NOVA-FAR_DETECTOR
BLOCK ASSY & INSTALLATION
NORTH/SOUTH DRIP GUTTER - LONG

SCALE	DRAWING NUMBER	SHEET	REV
1:4	3929.330-MC-493060	1 OF 1	A

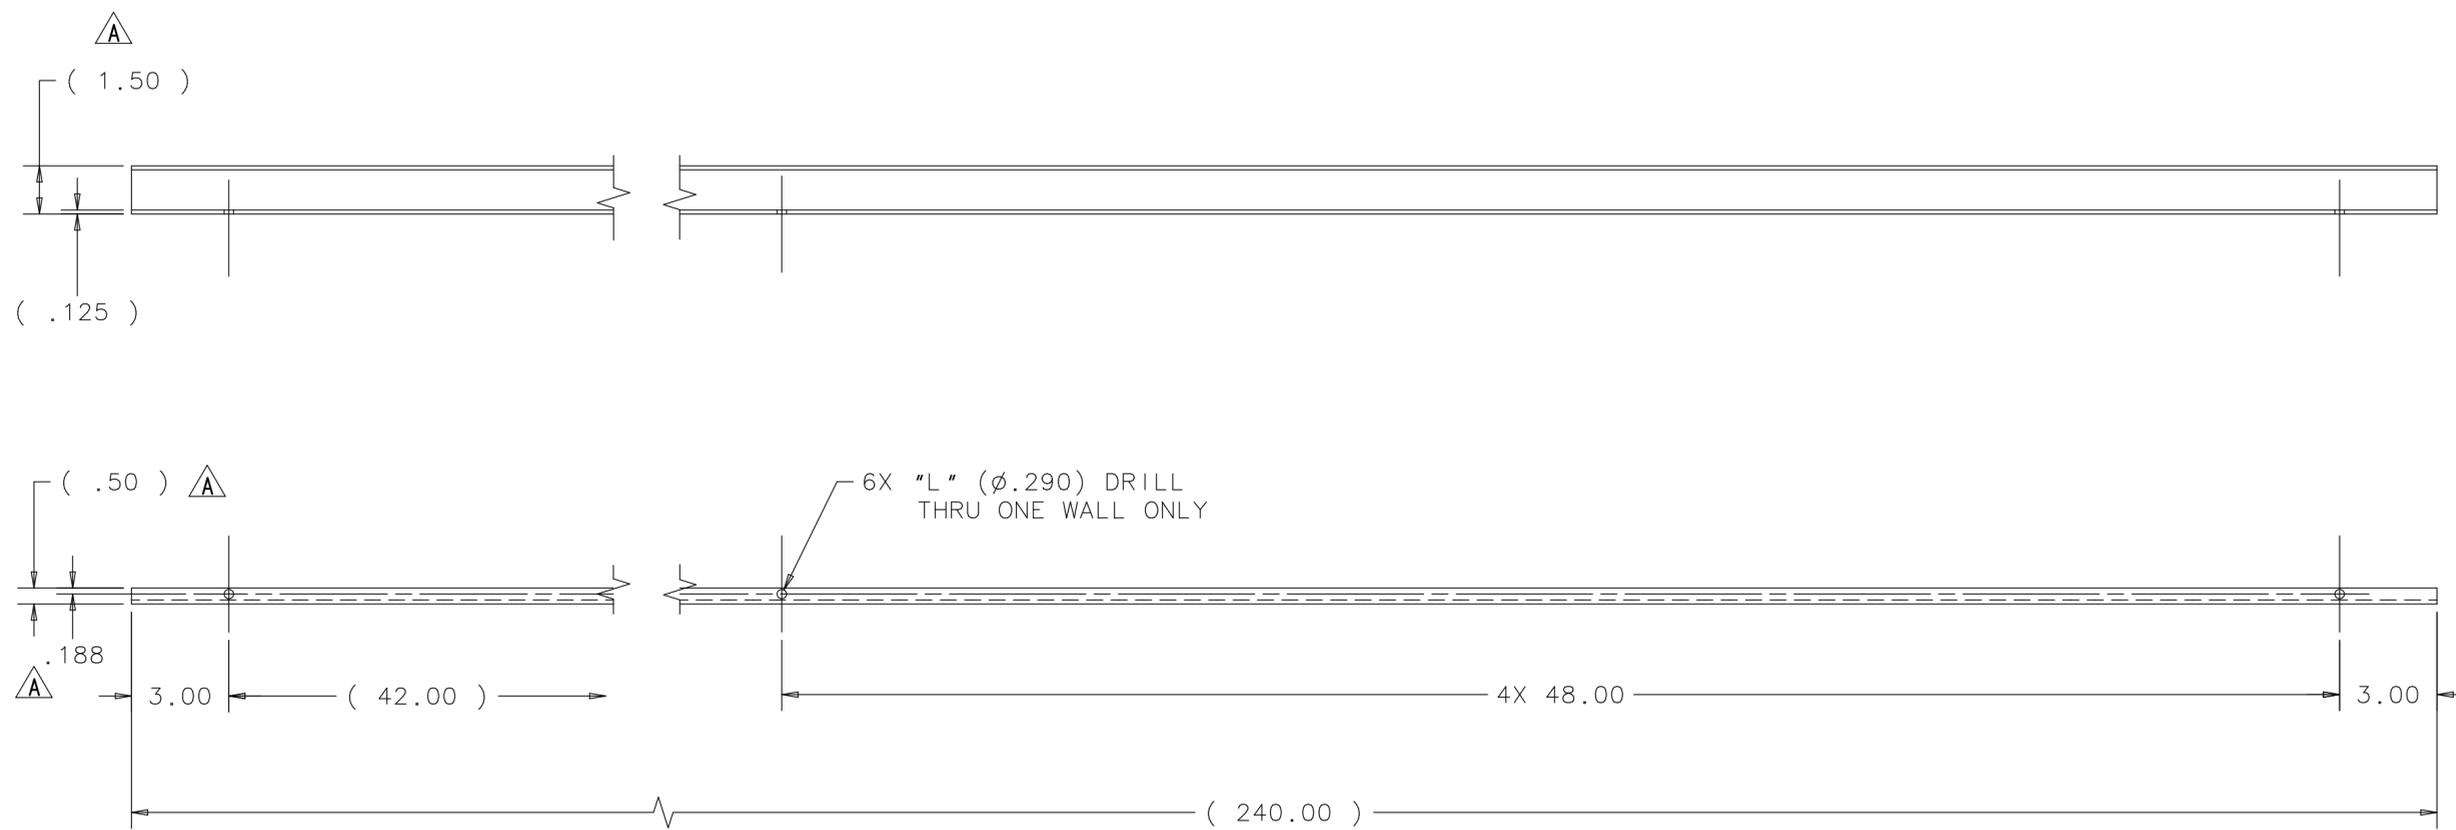
REV	DESCRIPTION	DRAWN	DATE
		APPROVED	DATE
A	CHANNEL WAS 2" X 1" X 1/8" DIM .188 WAS .380	D.FRIEND	05-DEC-2012
		J.RAUCH	06-DEC-2012
